## Director of Community and Economic Development

# UPDATE

April 25, 2022

## ■ Special Permit and Site Plan Review; 203 Ayer Road

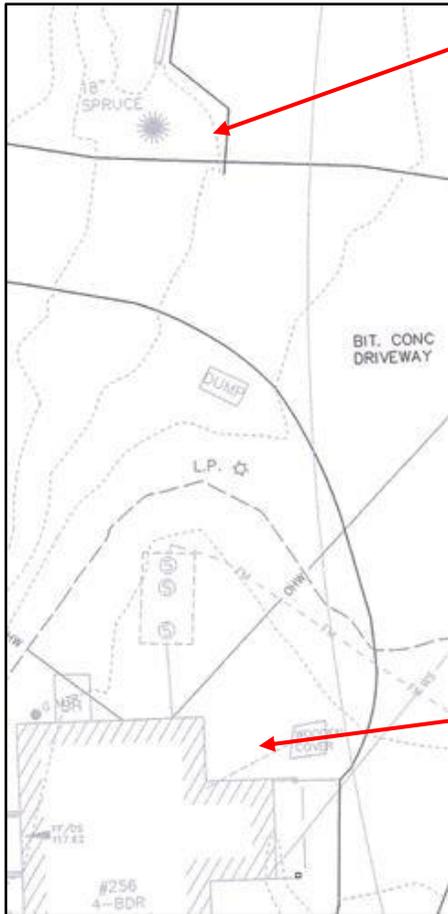
1. Need to determine if as-builts differ from originally approved plans.
2. Need to gauge if additional parking needed based on observed activity since opening and how much.
3. Need to determine optimal location for residential garbage container (see below). A better location for a residential container would be behind the residence.

**Proposed Location**

**Recommended Location**

The image below seems to indicate that this alternative waste receptacle location would be easily facilitated.
